UNITED STATES PATENT AND TRADEMARK OFFICE

| APPLICATION NO. | FILING DATE | FIRST NAMED INVENTOR | ATTORNEY DOCKET NO. | CONFIRMATION NO. |
|--|-------------|----------------------|--------------------------------|------------------------|
| 10/710,704 | 07/29/2004 | Jake Friedman | PES-0212 | 4703 |

| Office Action Summary | Application No. | Applicant(s) | |

DETAILED ACTION

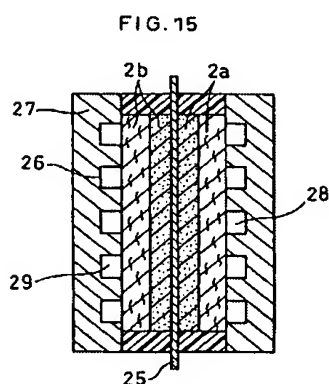
Yoshida et al disclose a polymer electrolyte fuel cell (*the electrochemical cell*) comprising an ion conductive polymer electrolyte membrane, a pair of gas diffusion electrodes provided to sandwich therebetween the polymer electrolyte membrane (P0035, 0124-0125),

thereby to form a polymer electrolyte membrane electrode assembly, and a pair of separator plates being provided to sandwich therebetween the polymer electrolyte membrane electrode assembly at the pair of gas diffusion electrodes and having gas flow channels to face the pair of gas diffusion electrodes respectively (P0035, 0124-0125), wherein the pair of gas diffusion electrodes respectively have a pair of catalyst layers to contact the polymer electrolyte membrane, and also have a pair of gas diffusion layers to contact the pair of catalyst layer (P0035, 0124-0125), wherein each of the gas diffusion layers comprises a carbon cloth having first mesh portions and second mesh portions, wherein the second mesh portions are coarser than the first mesh portions, and are distributed among the first mesh portions intermittently in a direction of the surface plane thereof (P0035, 0124-0125). *In this case, the gas diffusion layer represents the carbon layer comprising the integrated flow-channels and having the specified width.* **Figure 15** below illustrates the polymer electrolyte membrane 25; the gas diffusion electrodes 2a, 2b; and a pair of separator plates 27 having gas flow channels 26:

FIG. 13

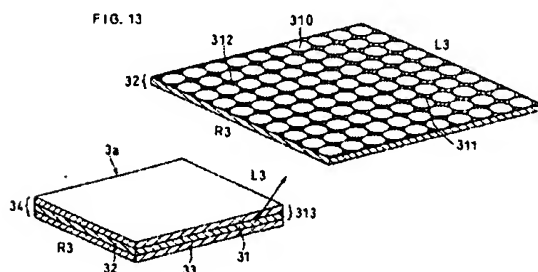
comprising a porous supporting body 31, made of carbon fibers, a polymer layer 32, and a catalyst layer 33 to form the gas diffusion layer 313 (P0132/FIGURE 13).

Figure 13 above illustrates flowchannels extending to the edge of the carbon layer.

Yoshida et al disclose a porous supporting body 31 (P0132/FIGURE 13).

FIG. 5

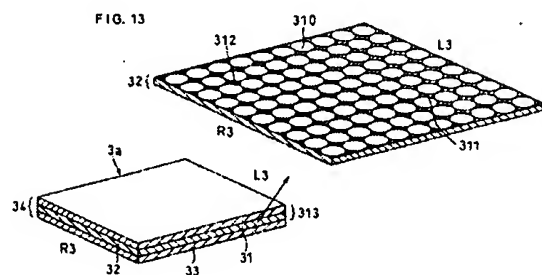
EXAMPLE I-2 exemplifies the use of a multi-layer carbon cloth 50 (P0095/FIGURE 5); or as comprising a porous supporting body 31, made of carbon fibers, a polymer layer 32, and a catalyst layer 33 to form the gas diffusion layer 313 (P0132/FIGURE 13). Each of the gas diffusion layers comprises a carbon cloth having first mesh portions and second mesh portions, wherein the second mesh portions are coarser than the first mesh portions, and are distributed among the first mesh portions intermittently in a direction of the surface plane thereof (P0035, 0124-0125). *In this case, the gas diffusion layer represents the carbon layer comprising the integrated flow-channels and having the specified width.* It can be appreciated that the flowchannels extend through the thickness of the layer and are situated inboard of the layer edge (See FIGURES 5 and 13).

FIG. 3

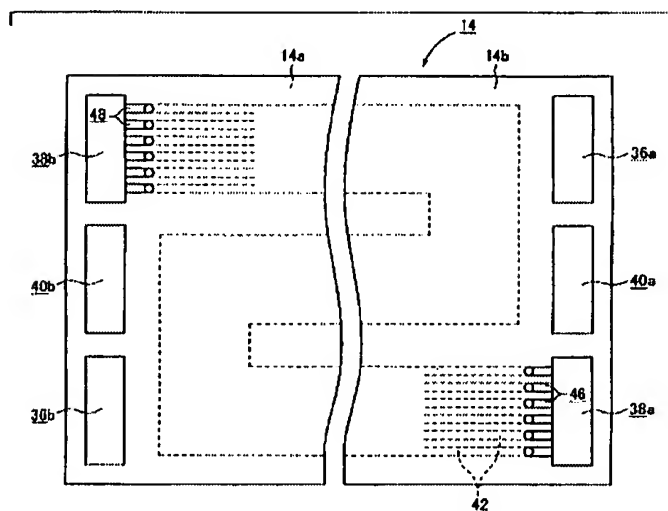
Yosida et al'001 teaches a fuel cell including a solid polymer exchange membrane sandwiched the anode electrode and the cathode electrode (ABSTRACT/COL 1, lines 14-20) with a fuel cell element comprising a plurality of continuous uninterrupted flowchannels wherein the width of the flowchannels is at least equal to or less than width of the webbing between adjacent flow channels, and wherein the length of the flowchannels is greater than the width thereof, and the length of the flow channel extends substantially from one edge of the element to the opposite edge thereof (See **FIGURES 3 and 5-6**).

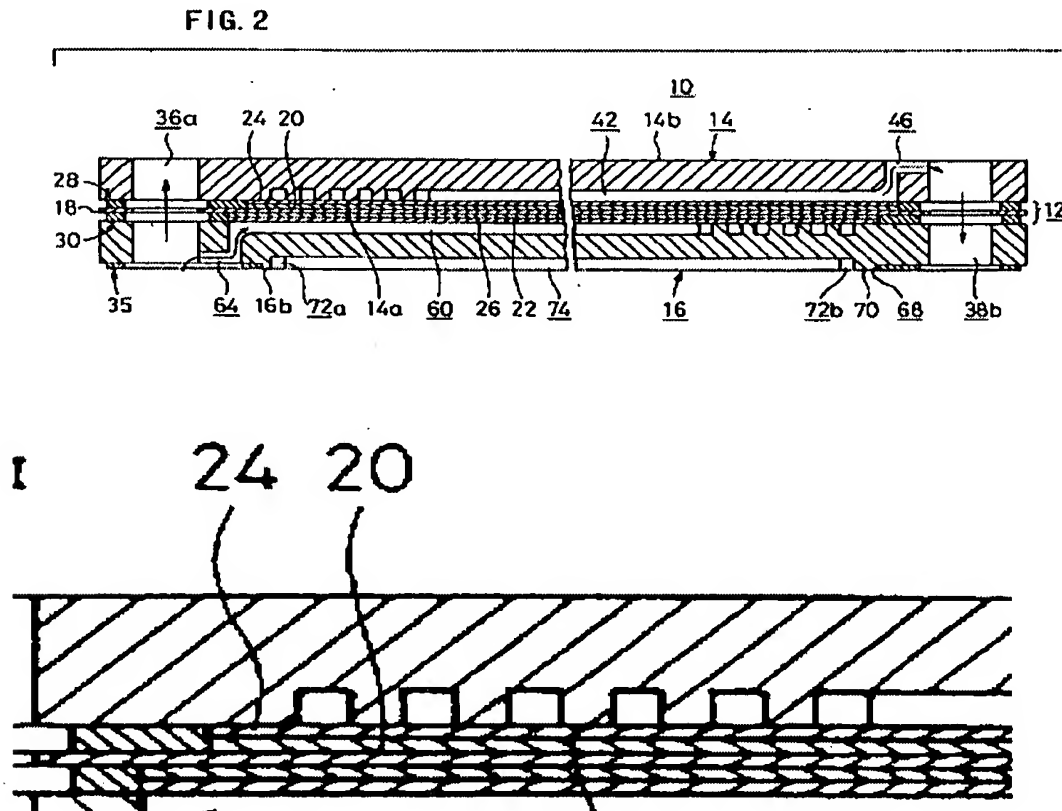
Figure 2 of Yosida et al illustrates the fuel cell element wherein the depth of the flowchannels is less than its thickness (See **FIGURE 2** and **Enlarged Portion of FIGURE 2**):
